VICTORIAN CIVIL AND ADMINISTRATIVE TRIBUNAL

VCAT REFERENCE NO. P11611/2021
PERMIT APPLICATION NO.TPA/52646

APPLICANT	Anthea Karpathakis
RESPONSIBLE AUTHORITY	Monash City Council
SUBJECT LAND	123 View Mount Road, GLEN WAVERLEY VIC 3150
HEARING TYPE	Hearing
DATE OF HEARING	6 June 2022
DATE OF ORDER	6 July 2022
CITATION	Karpathakis v Monash CC [2022] VCAT 753

Permit granted

Extract of ground floor plan showing kitchen window of unit 2.

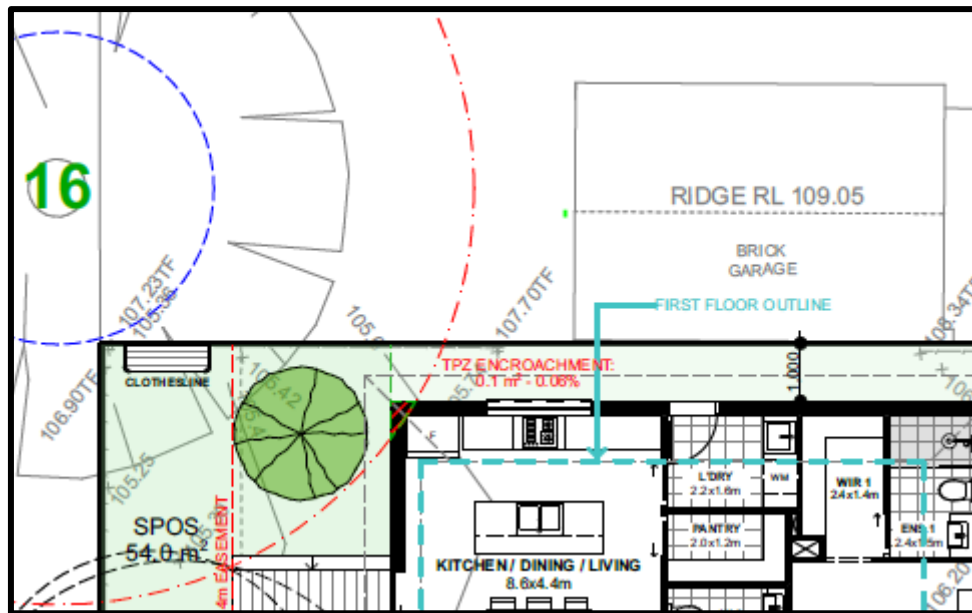
- 40 The council raised concerns with respect to the kitchen window of unit 2 not meeting the requirements of Standard B27 of clause 55.05-3 for daylight access. It said:

The proposed north facing kitchen window associated with dwelling two does not provide one metre clear to the sky, or a light court of 3m² as required under standard B27.

Given the proposal is effectively starting with a clean site which does not have any significant constraints, it is not considered an acceptable outcome for a habitable room window to be provided with compromised daylight access. The building should be set back further or modified some way in order to satisfy the standard.

- 43 Part of the reason for the non compliance is the eave and the other is the setback of the eave and window from the northern boundary. Although the kitchen window is set back from the boundary by 1 metre, the eave is set back approximately 500mm from the boundary.
- 44 The council suggested that the eave could be removed above the window in order to achieve compliance.
- 45 I agree with both parties with their respective arguments. I accept that the proposal does not meet Standard B27 but that the eave would also provide appropriate solar protection during the summer months.
- 46 In this case, I will not require compliance with Standard B27 but require either an additional window to the western elevation adjacent the kitchen or a skylight centrally located above the kitchen area as a condition. I find that either of these solutions will ensure adequate daylight to the kitchen area.

- (b) The deletion of the upper floor balcony to the master bedroom 2 of unit 1.
 - (c) The addition of a skylight centrally located over the kitchen of unit 2 or a window on the ground floor west elevation wall of unit 2 adjacent to the kitchen.
